September 16, 2020

Reference: Response to Peer Review Comments  
Application for Site Plan Review  
27 Charge Pond Road PV+ES Project  
Wareham, Massachusetts  
B+T Project No. 1833.109

**C-3.1**  
LAYOUT AND MATERIALS PLAN - SOUTHWEST

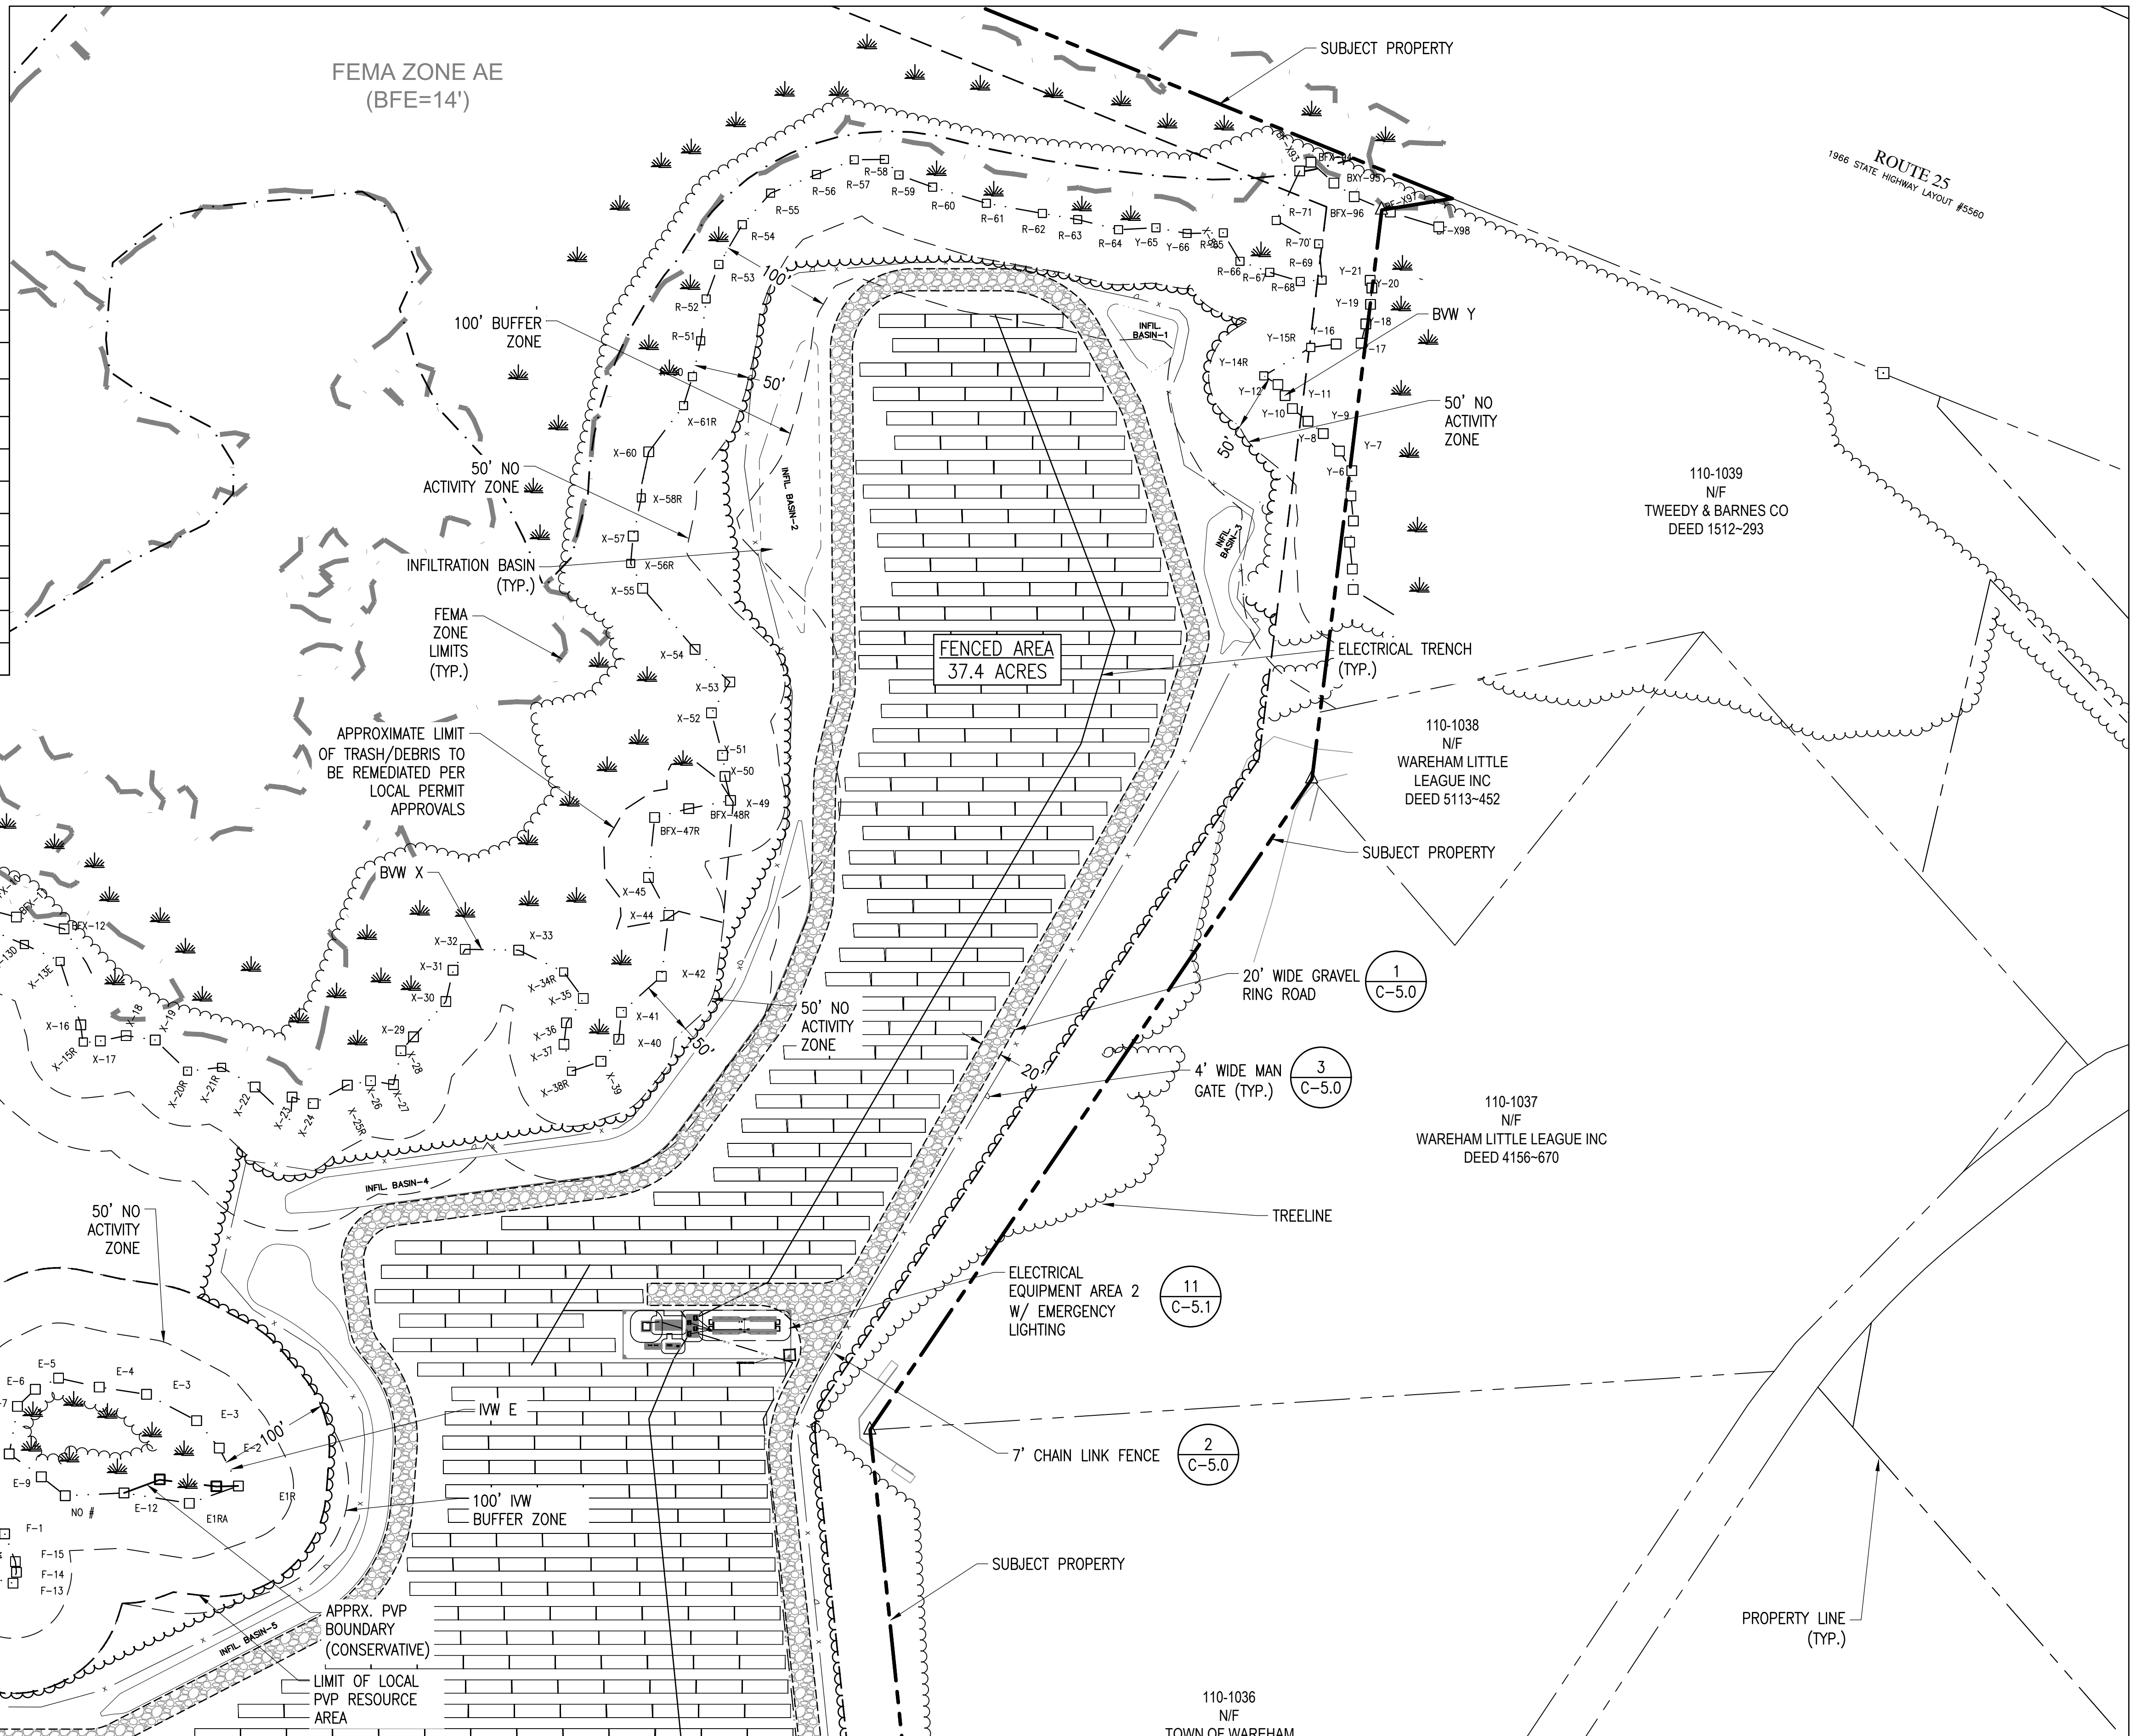
- 5. The southwestern portion of the site has the most extreme contour differences that change from elevation 16 at Parker Mills Pond to elevation 43 near the narrow area lying between two isolated wetlands.*

In the vicinity of Parker Mills Pond, the previously-proposed 65-linear foot wooded buffer (on average) from the edge of Tihonet Pond has been increased by 15-feet (on average) to 80 linear feet (on average). More specifically, although the minimum width of woods (50+ feet) remains similar at the north edge of the western lobe of solar panels, the width in other areas has been increased from the previous maximum of 73 feet to a current maximum of 128 feet. Please refer to Sheet C-3.1.
